**Amendments to the Drawings:**

The attached sheets of Figure 1 and Figures 2 - 4 include corrections to Figure 1 and Figure 4 as indicated below.

Fig. 1

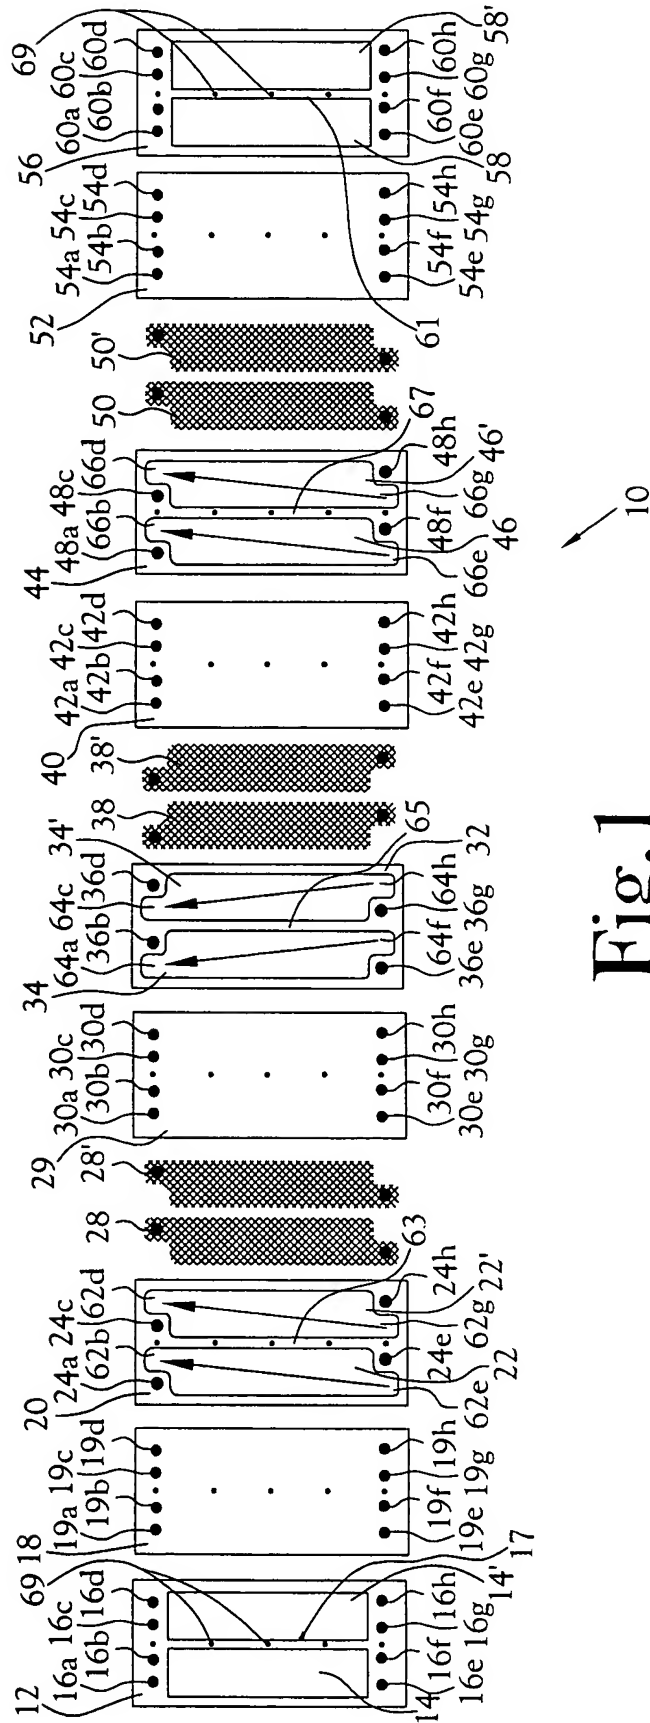
In Figure 1, element numbers for centrally positioned partitions 17, 63, 65, 67 and 61 are included for spacers 12, 20, 34, 44, and 56. Each partition is illustrated as having aligned holes therein, as indicated by element 69. In regards to spacer 12, a separate lead line and element number 14' is added. In regards to spacer 56, elements 14 and 14 are deleted, with each aperture identified as 58, 58'.

Fig. 4

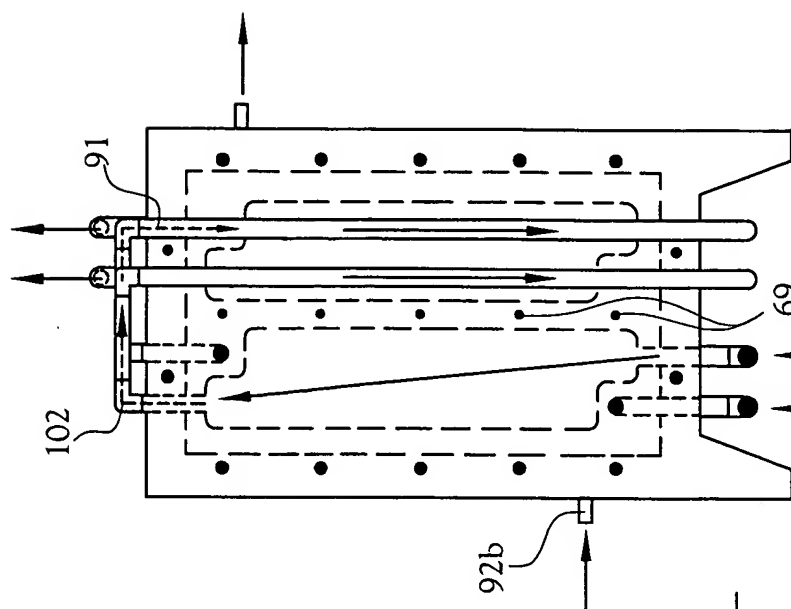
In Figure 4, the partition between the two apertures is illustrated as having aligned holes therein, as indicated by element 69.
